**PROPOSED MIDDELWATER CLASS B  
WASTE FACILITY**

**ADDENDUM TO DESIGN REPORT**

**REVISION 2**

**Ref. No.755-2022  
January 2026**

B.L. JEWASKIEWITZ  
 Pr. Eng. 20170189  
 DATE:.....16/01/26

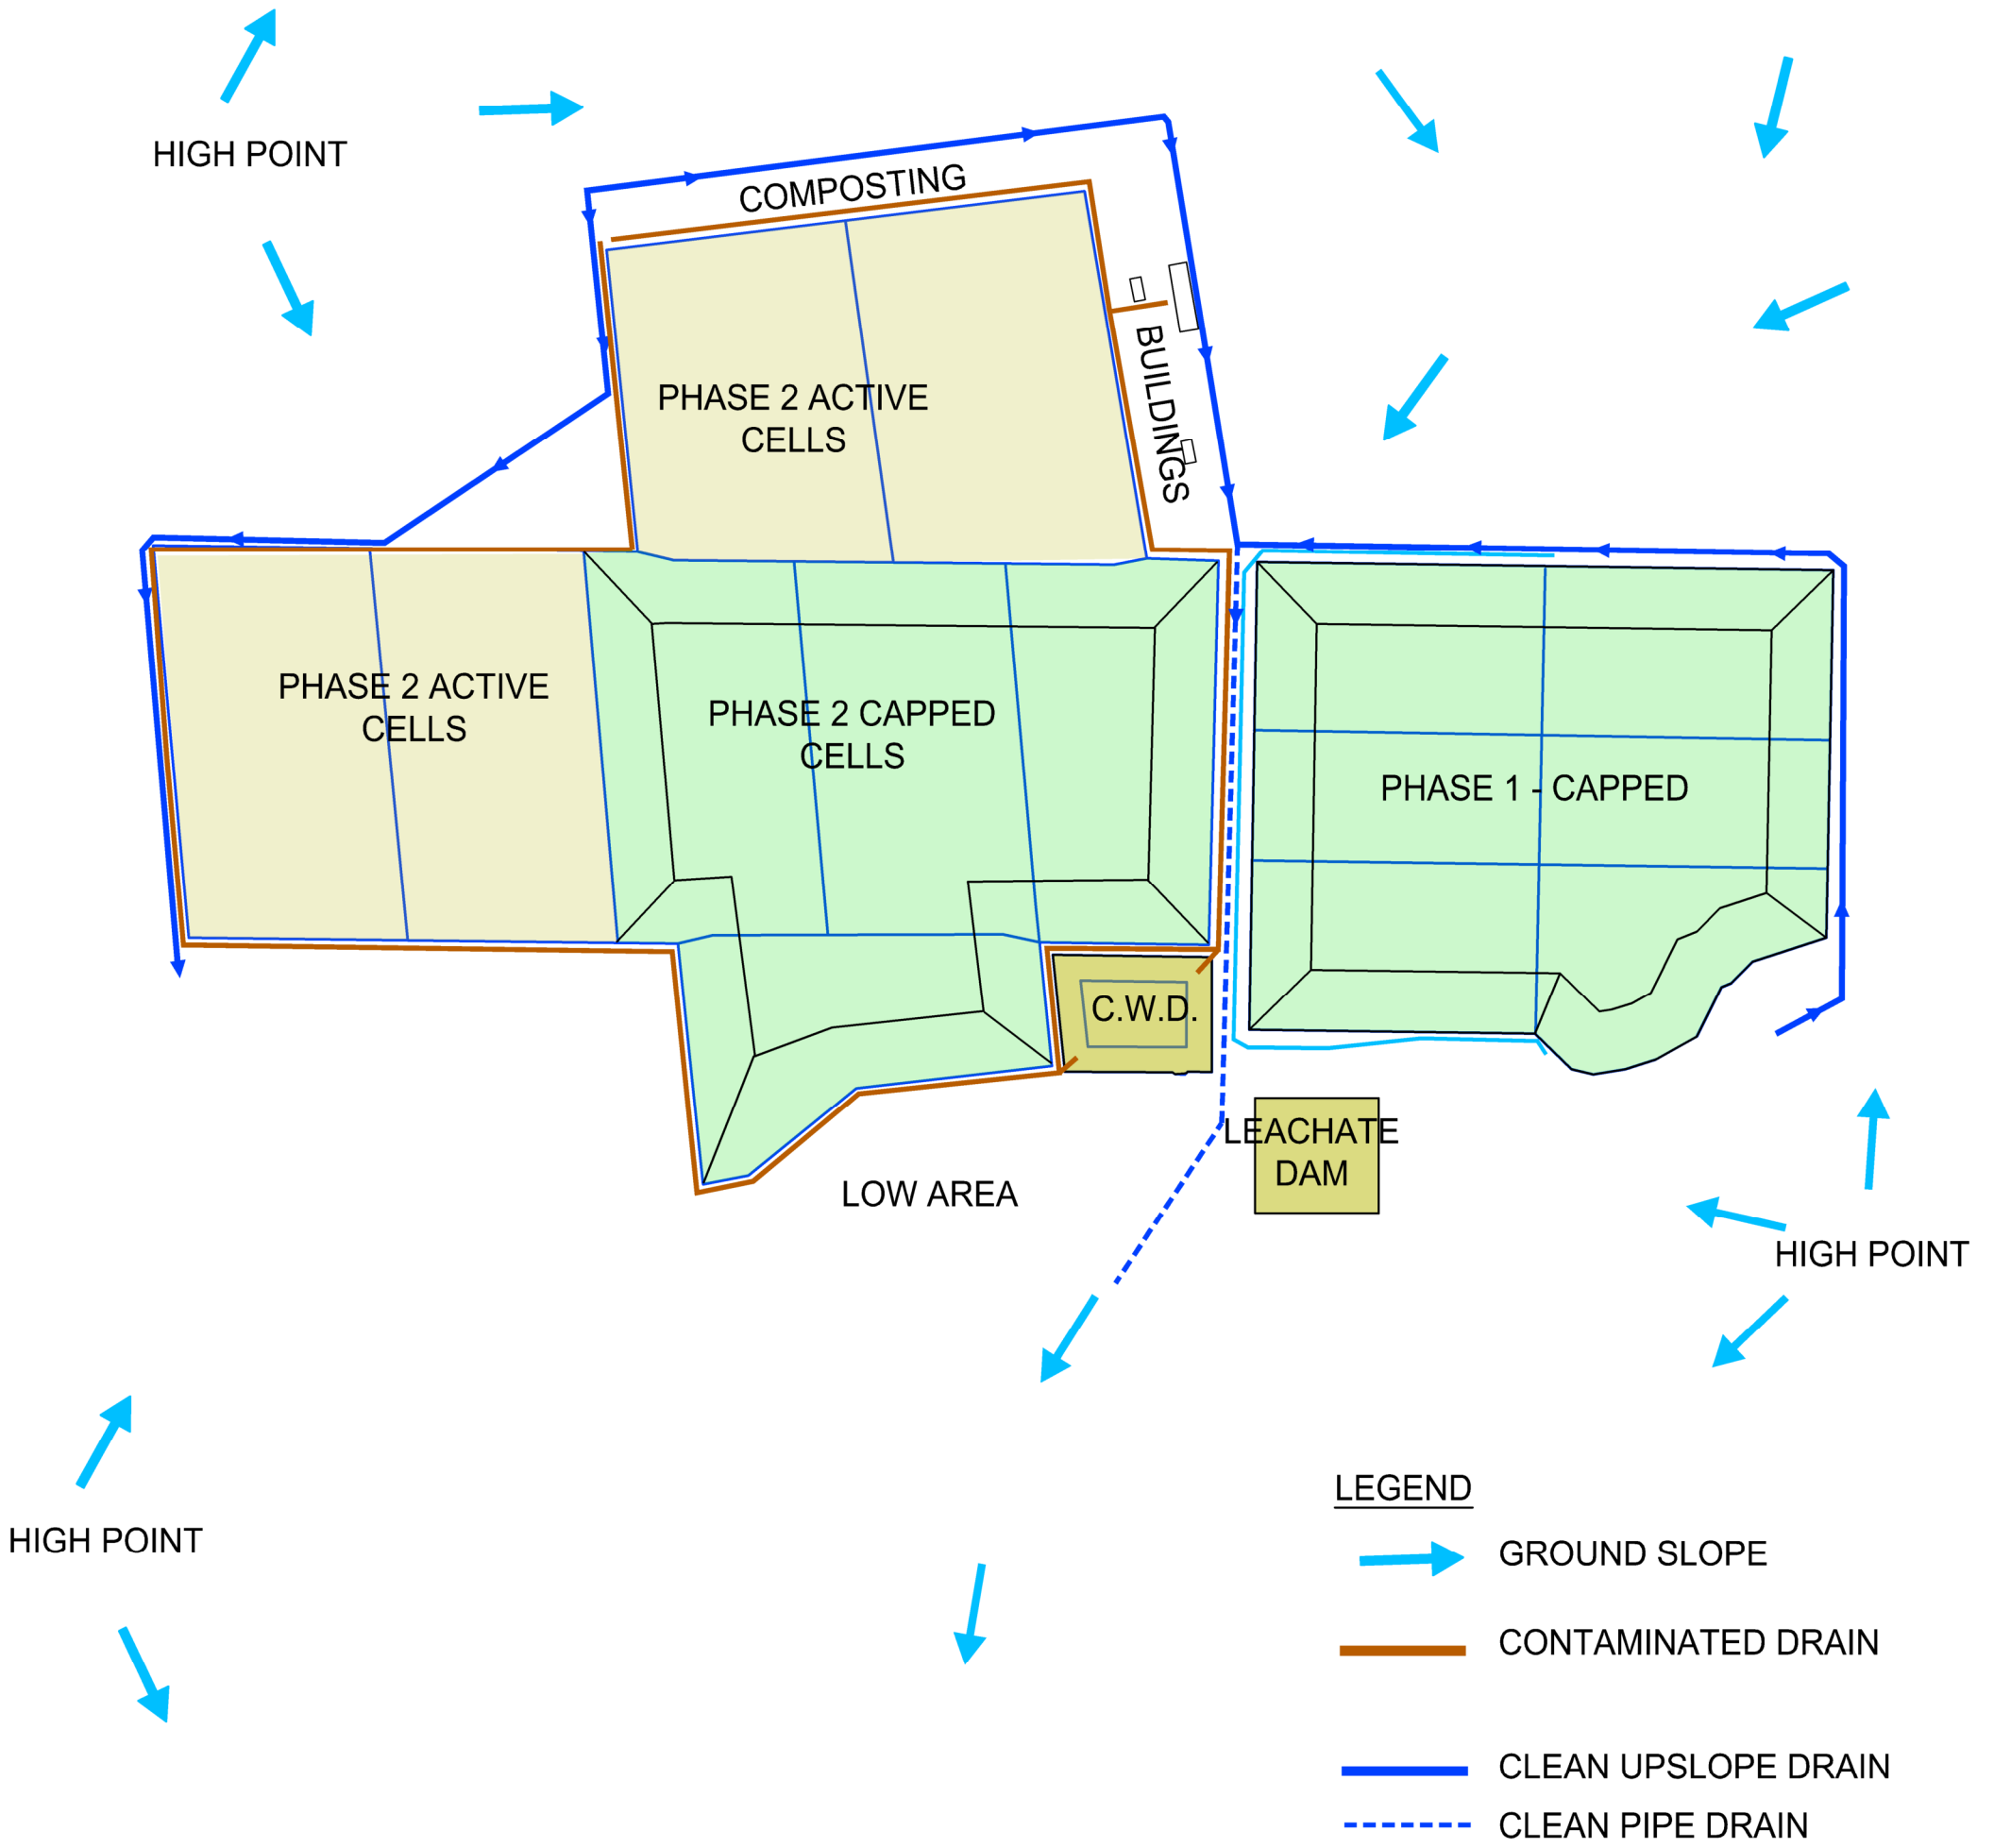
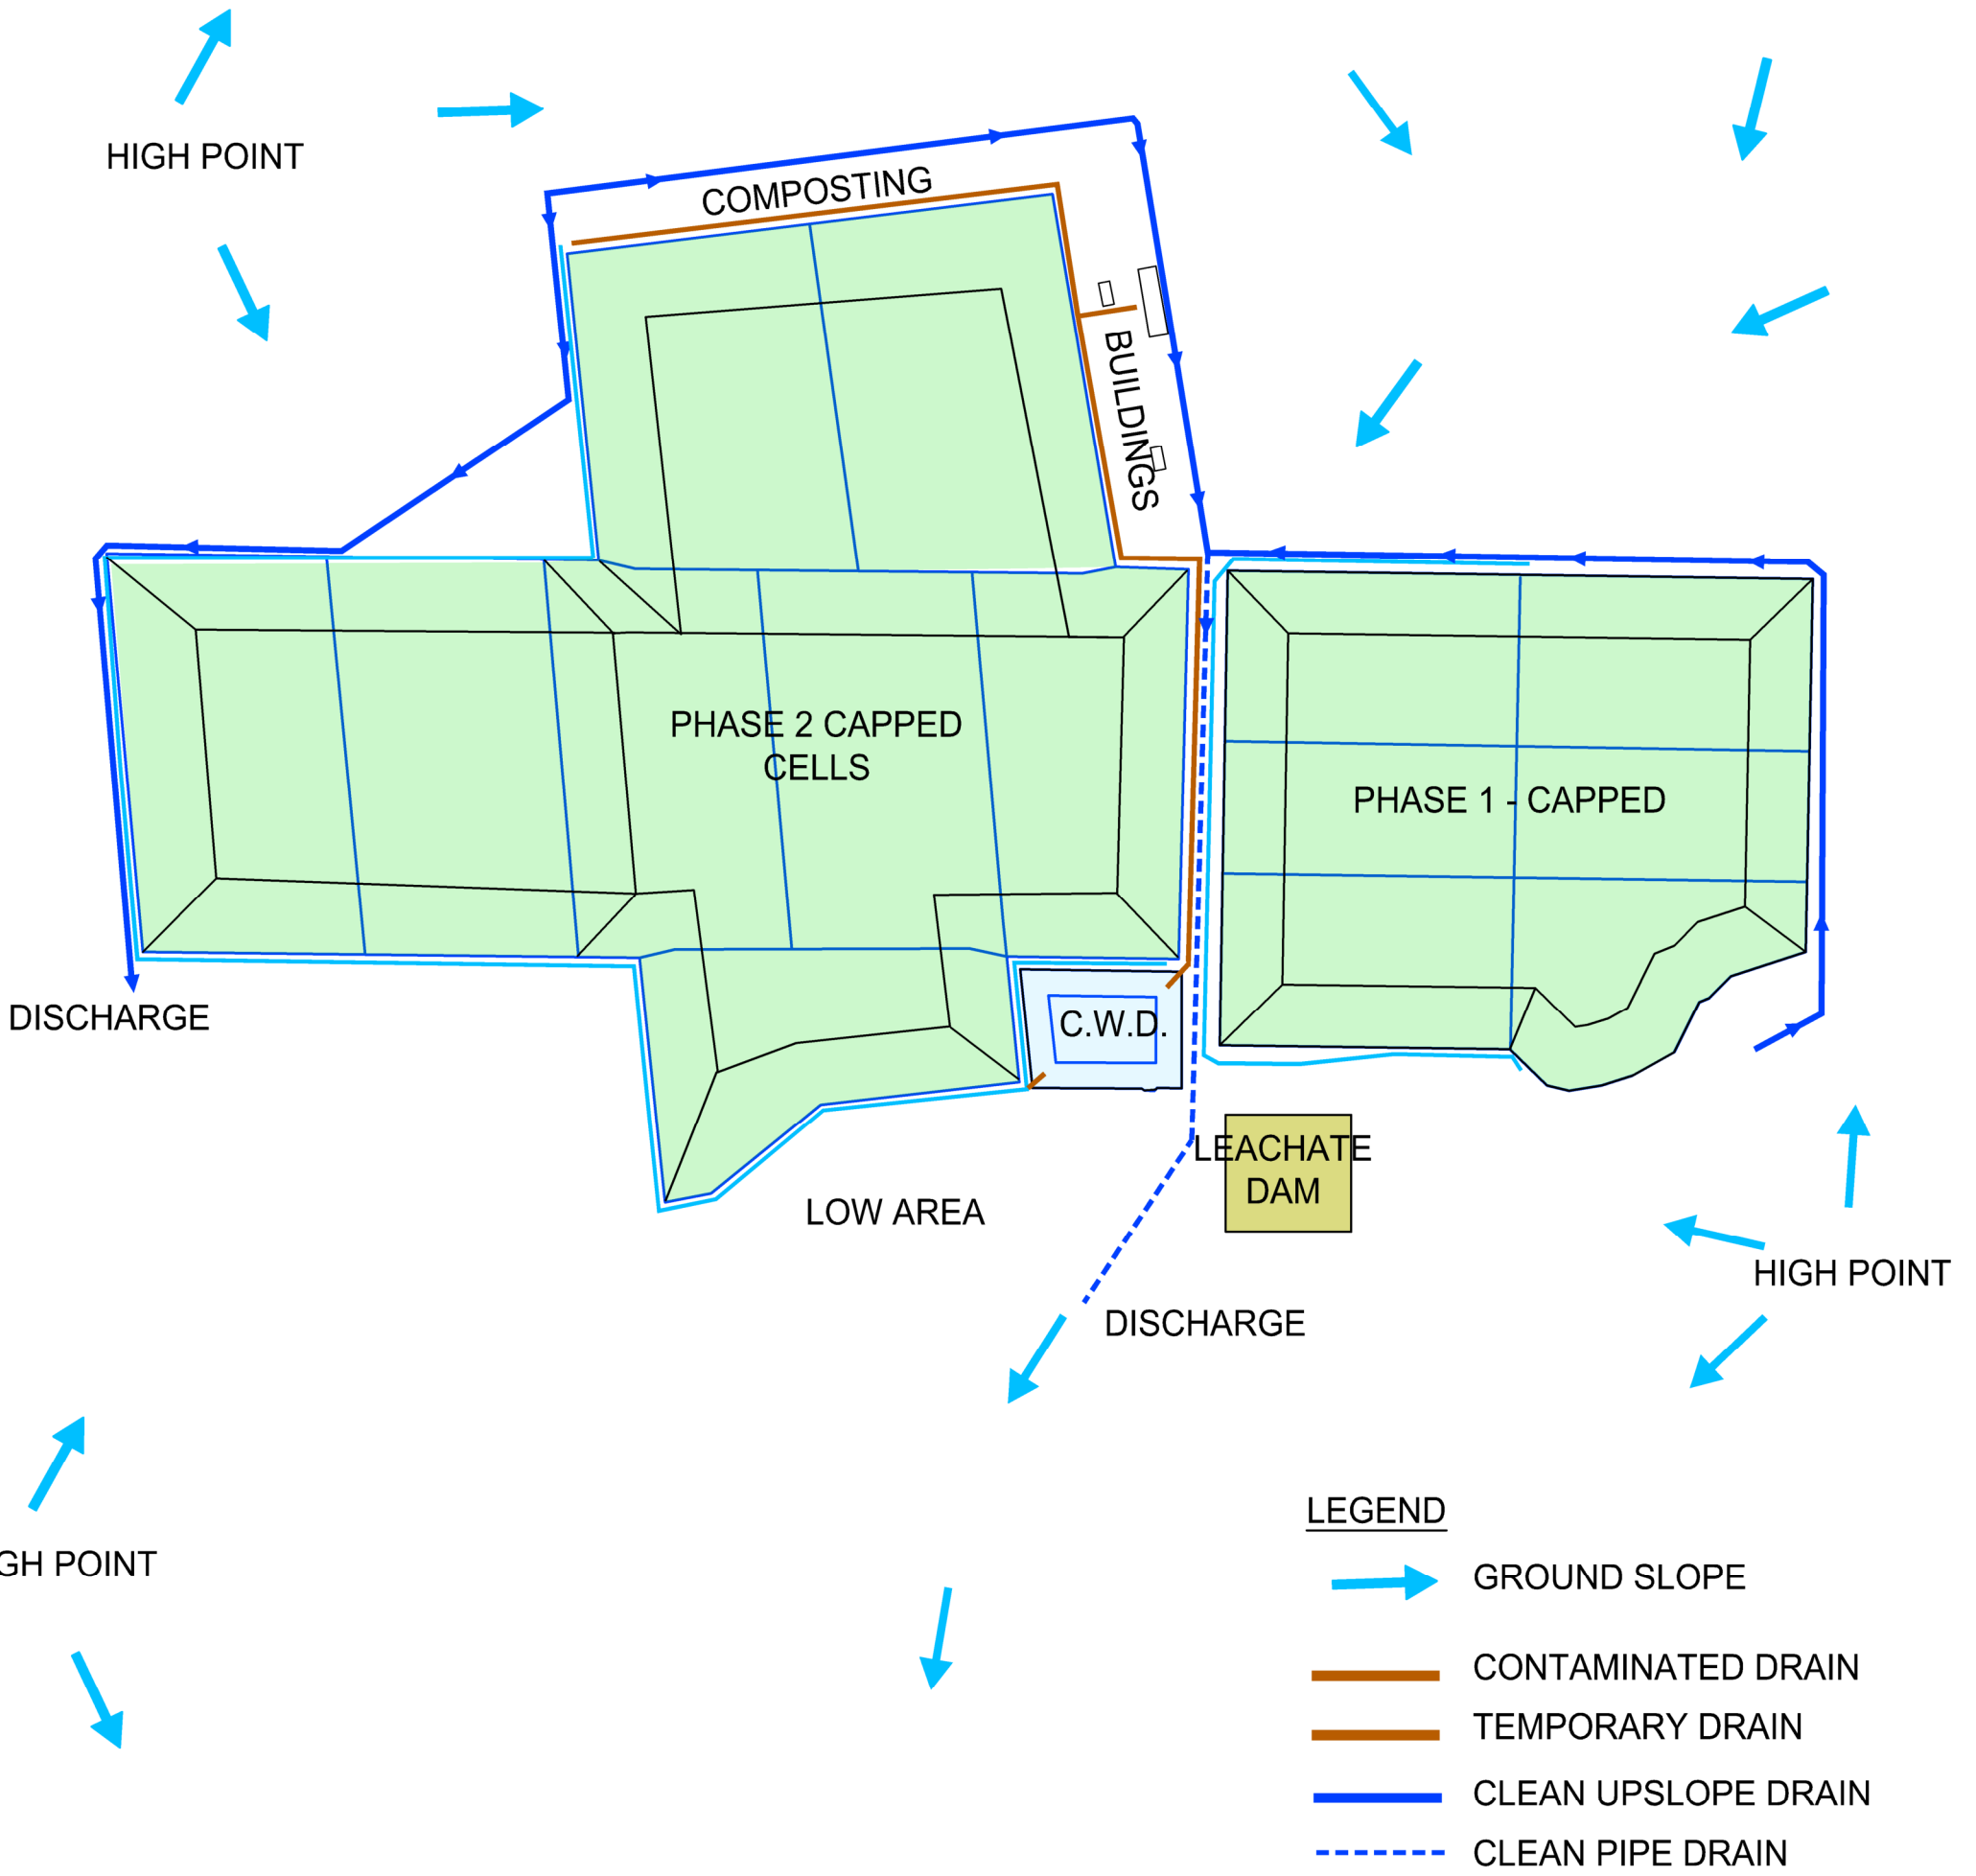
2.1	<p>Middelwater Resource Facility (Pty) Ltd must provide a flow diagram identifying the source and destination of clean stormwater runoff, polluted stormwater runoff, and leachate, recognising the change to runoff areas with time.</p>	Envitech	<p>Envitech to show a diagram for clean stormwater, polluted water separation per phase. See sketches at the 755-2022-SK01 to SK05 with the project drawings.</p>

- 2.1 Middelwater Resource Facility (Pty) Ltd must provide a flow diagram identifying the source and destination of clean stormwater runoff, polluted stormwater runoff, and leachate, recognising the change to runoff areas with time.

DRAWING TITLE	SHEET NO.	DRAWING NO.
CELL 1 SECTIONS	1 OF 1	755 - 2022 - 008 - REV-B

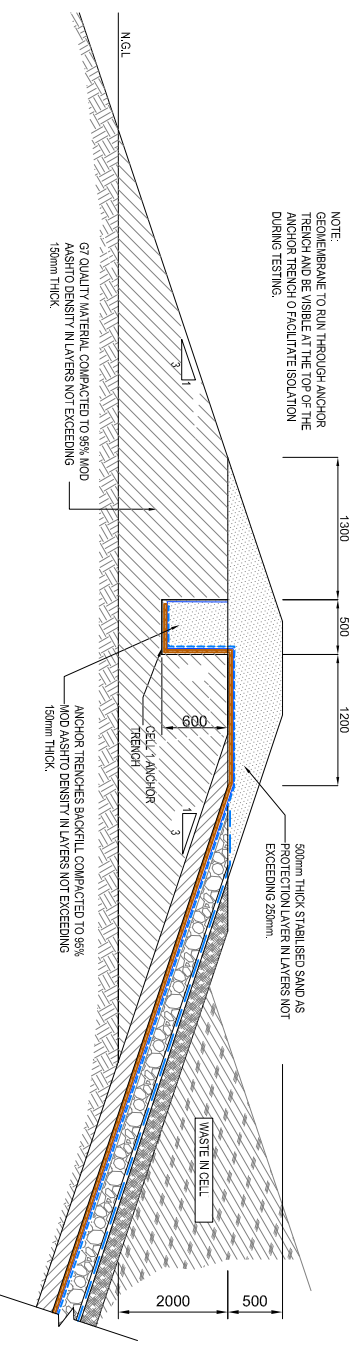
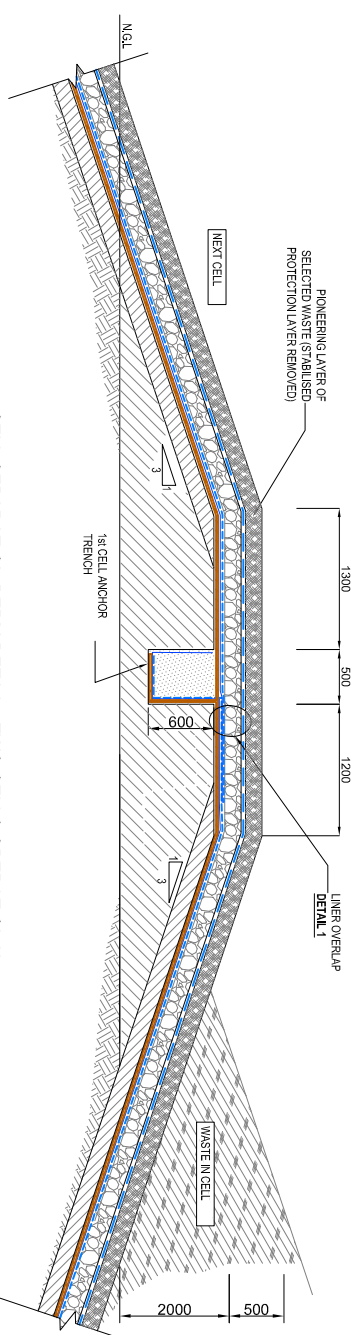
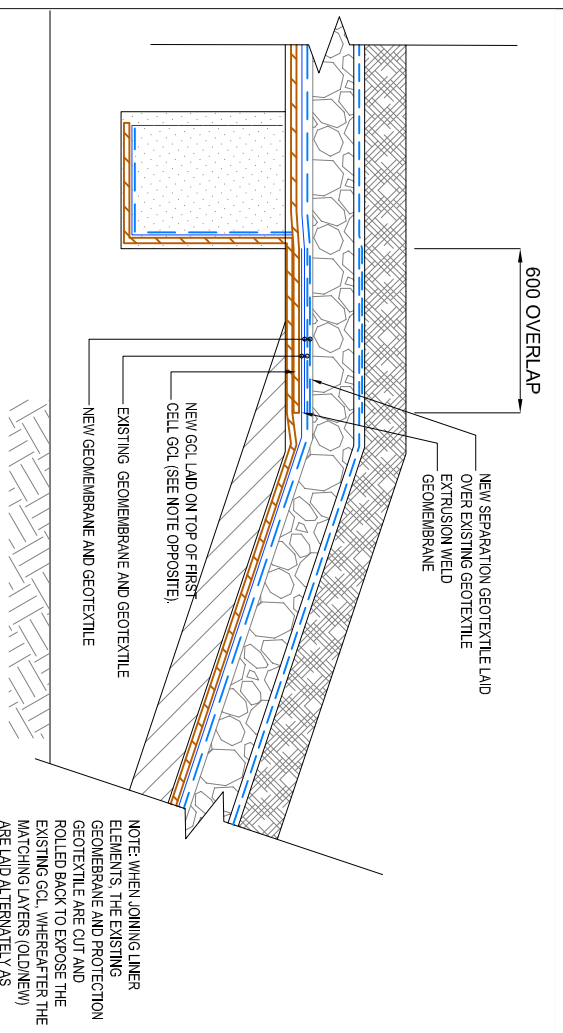
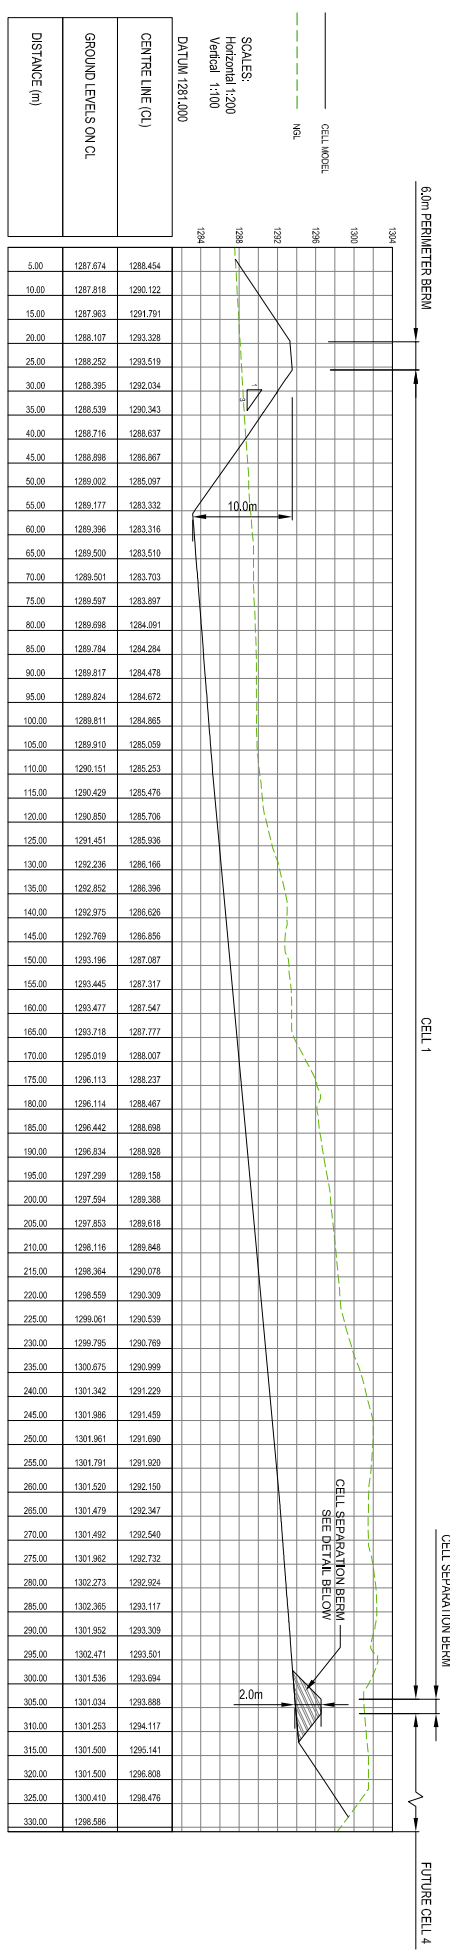
2.9	<p>Middelwater Resource Facility (Pty) Ltd must develop a design drawing which details and confirms the continuity of</p>		<p>Please see drawing no: ES755-2022-008 rev B for separation berm details.</p>

<p>containment for the separation of berm anchor trenches between successive waste cells.</p> <ul style="list-style-type: none"> <li>• The design drawing must be submitted to the Department for approval, together with the amended documents.</li> </ul>

- 2.9 Middelwater Resource Facility (Pty) Ltd must develop a design drawing which details and confirms the continuity of containment for the separation of berm anchor trenches between successive waste cells.

NOTE: WHEN JOINING LINER ELEMENTS, THE EXISTING GEOMEMBRANE AND PROTECTION GEOTEXTILE ARE CUT AND ROLLED BACK TO EXPOSE THE EXISTING GCL. WHEREAFTER THE MATCHING LAYERS (OLD/NEW) ARE LAID ALTERNATIVELY AS SHOWN.

NOTE:  
GEOMEMBRANE TO RUN THROUGH ANCHOR TRENCH AND BE VISIBLE IN THE TOP OF THE ANCHOR TRENCH TO FACILITATE ISOLATION DURING TESTING.
